**WHITLEY COUNTY ADVISORY PLAN COMMISSION  
STAFF REPORT**

**21-W-SUBD-6    PRIMARY PLAT APPROVAL**  
Vision Homz, LLC  
Arrowhead Pointe

**APRIL 21, 2021**  
**AGENDA ITEM:    2**

**S1**

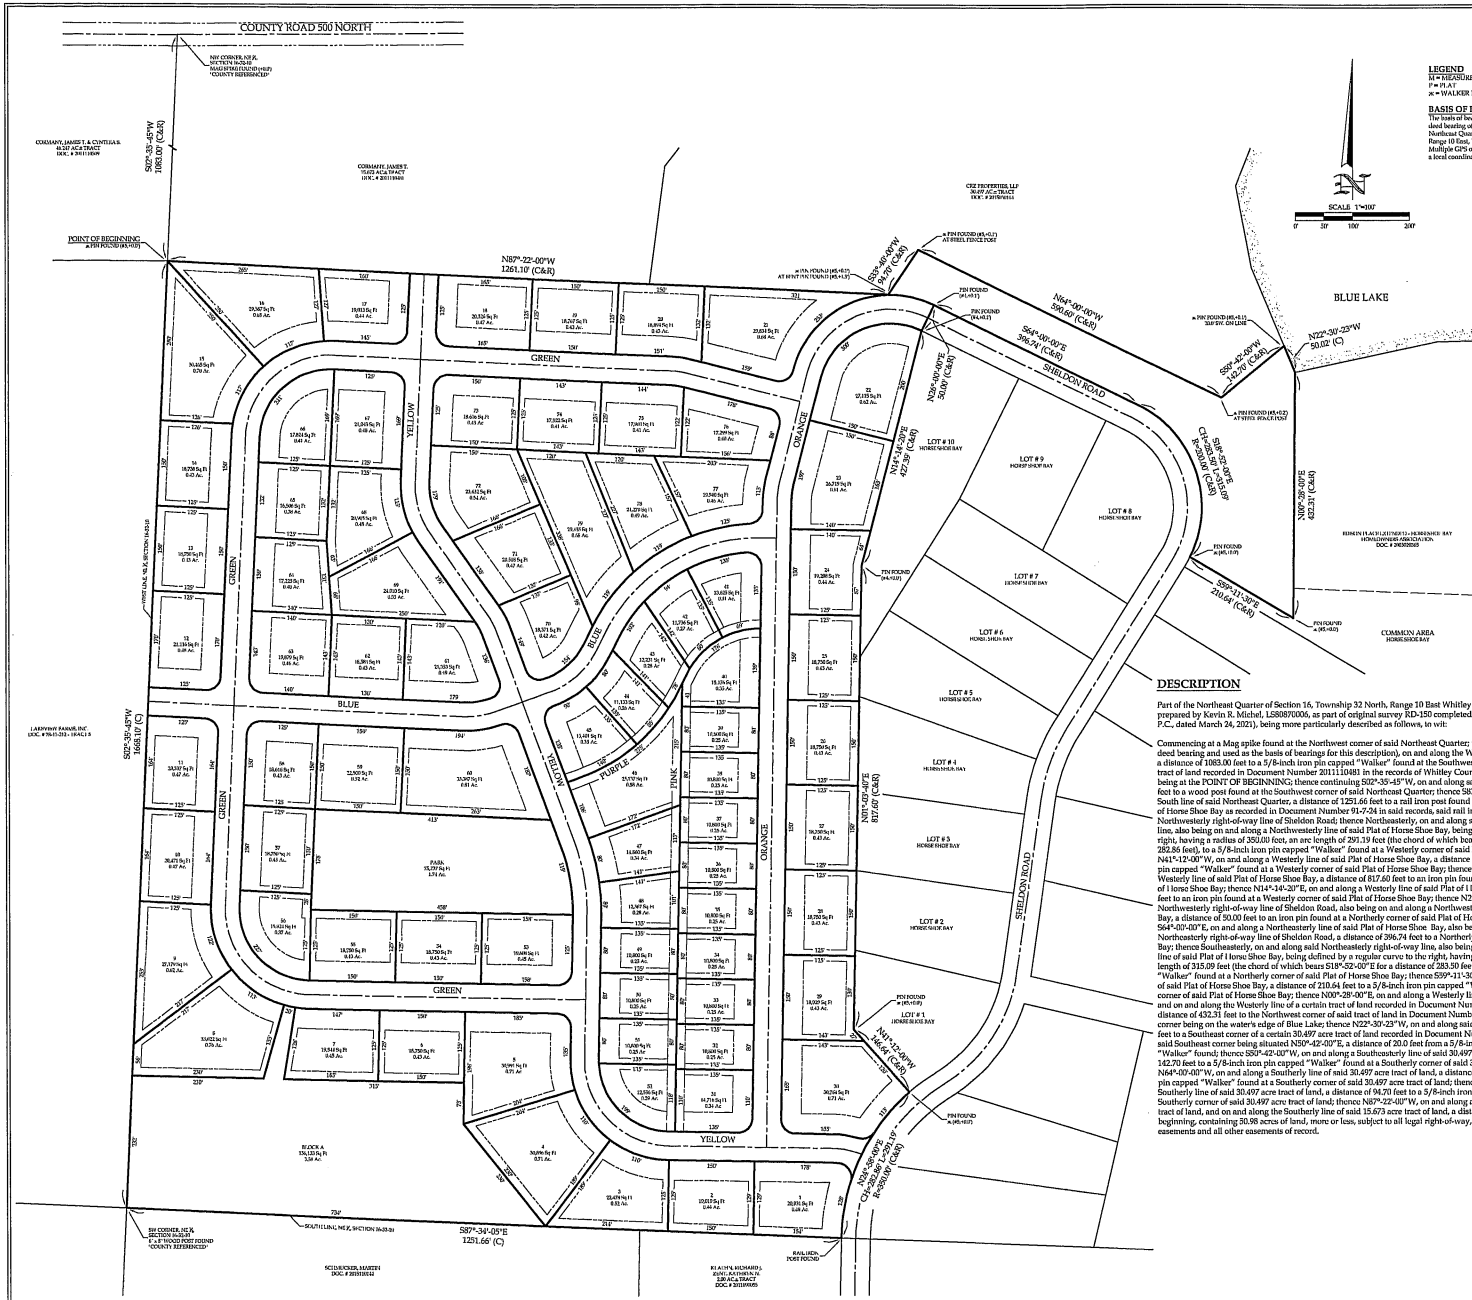
The non-designated block with lake frontage is subject to the lake access standards of §5.3.1. With 50.02' of lake frontage, one lot may have lake access; all others would be required to use the public access.

The proposed plat accesses Sheldon Road, a paved public road. Stub streets are located to provide access to any future development on the adjacent parcels to the north and west. A traffic study and/or management plan may be required by the Plan Commission prior to or as a condition of primary plat approval. The Commission may give this consideration as part of the hearing.

No landscaping is shown on the primary plat. The code requires a 20' wide landscape area adjacent to perimeter roads, which may be an easement incorporated into lot area. In this case, perimeter landscaping will be required on the frontage of Sheldon Road. Individual lot landscaping is also required; this is checked during building inspections. Section 24 of the proposed Covenants may also be an appropriate location to state these requirements.

The proposed primary plat does not indicate provision for sidewalks, but Section 19 of the proposed Covenants does state that sidewalks will be constructed.

The internal roads being proposed would be within 50' rights-of-way, which are compliant for subdivision streets. However, a through street, such as Yellow Street, might be more appropriately designated as a local road with a slightly higher pavement specification and 60' right-of-way width.

The County Engineer provided comment that Sheldon Road already exceeds the 1,000' length/20 lot maximums permitted under the County Highway Specifications. Additionally, he stated that "due to the age and condition of Sheldon Road, it could not sustain the amount of construction traffic that would be necessary to develop the proposed subdivision." He suggests that a construction entrance to Anderson Road and/or improvements be made to Sheldon Road, with further comment reserved for construction plans.

The Soil and Water Conservation District provided several comments. The soil types present may require special concern for erosion control and may not permit construction of basements. He expressed concern about the lack of public water supply for a subdivision.

Orange Street contains the longest block, at 1,075'. This is over the maximum block length stated in §504 of the Subdivision Code, but the length may be permitted if pedestrian ways are provided near the center of the block.

Section 503.5 of the Subdivision Code does not permit alleys in residential areas, but it does discuss them for commercial and industrial areas, including minimum design standards. Since the proposal is not for alleys that would be publicly maintained in public rights-of-way, this may not apply.

- The adequacy of Sheldon Road to serve the proposed subdivision, both during construction and permanently, and any improvements that may be necessary.
- The appropriateness of approving over 42 lots in this primary plat, based on the stated capacity of the current sanitary sewer
- Additional details on the proposed drainage system to ensure any existing drainage issues are not exacerbated
- Clarification of compliance with the Lake Access standards of §5.3.1, and clarification of the purpose of the non-designated block on the northeast side of the plat
